FIRST NAMED INVENTOR ATTORNEY DOCKET NO. CONFIRMATION NO. APPLICATION NO. **FILING DATE** 8950 09/737,770 12/18/2000 In-Duk Song 8733.339.00 **EXAMINER** 06/30/2005 30827 7590 MCKENNA LONG & ALDRIDGE LLP RUDE, TIMOTHY L 1900 K STREET, NW PAPER NUMBER ART UNIT WASHINGTON, DC 20006 2883

Application No.	Applicant(s)			
Office Antique Commence	09/737,770	SONG, IN-DUK			
Office Action Summary	Examiner	Art Unit			
	Timothy L. Rude	2883			
The MAILING DATE of this communication appears on the cover sheet with the correspondence address Period for Reply					
A SHORTENED STATUTORY PERIOD FOR REPLY IS SET TO EXPIRE 3 MONTH(S) FROM THE MAILING DATE OF THIS COMMUNICATION. - Extensions of time may be available under the provisions of 37 CFR 1.136(a). In no event, however, may a reply be timely filed after SIX (6) MONTHS from the mailing date of this communication. - If the period for reply specified above is less than thirty (30) days, a reply within the statutory minimum of thirty (30) days will be considered timely. - If NO period for reply is specified above, the maximum statutory period will apply and will expire SIX (6) MONTHS from the mailing date of this communication. - Failure to repl

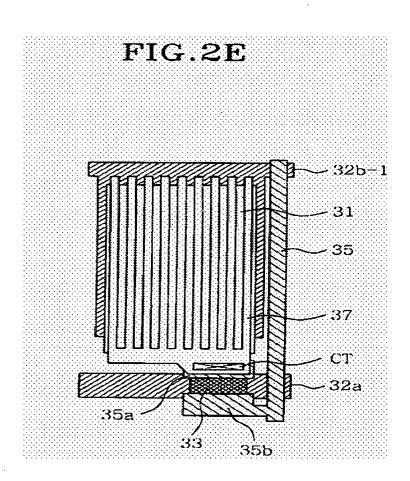
The drawings are objected to because item 60 overlaps item 54, but the overlap is not clearly shown; the lines of 54 should discontinue under item 60. Corrected drawing sheets in compliance with 37 CFR 1.121(d) are required in reply to the Office action to avoid abandonment of the application. Any amended replacement drawing sheet should include all of the figures appearing on the immediate prior version of the sheet, even if only one figure is being amended. The figure or figure number of an amended drawing should not be labeled as "amended." If a drawing figure is to be canceled, the appropriate figure must be removed from the replacement sheet, and where necessary, the remaining figures must be renumbered and appropriate changes made to the brief description of the several views of the drawings for consistency. Additional replacement sheets may be necessary to show the renumbering of the

As to claims 2, 4, 5, 7, 10, 12, and 21-22, APA discloses in Figure 8 an in-plane switching liquid crystal display (LCD) device comprising: common electrodes, 54a, alternating and parallel with pixel electrodes, 66a, and a gate line, 50, for a TFT and a common line, 54, wherein common electrodes are arranged to directly contact the

APA discloses in Figures 7A and 7B (more clear illustration than Figure 8 in these regards, Figure 8 is objected to above) that the scan line, 2 (gate line), is conventionally formed on the substrate, 1A, and that the reference signal line, 4 (common line), and the reference electrode, 14 (common electrode), are also formed on the same substrate (Applicant's wherein the common electrode is formed on the substrate like the gate line) and a are covered by a first insulating film, 11 (gate-insulating layer).
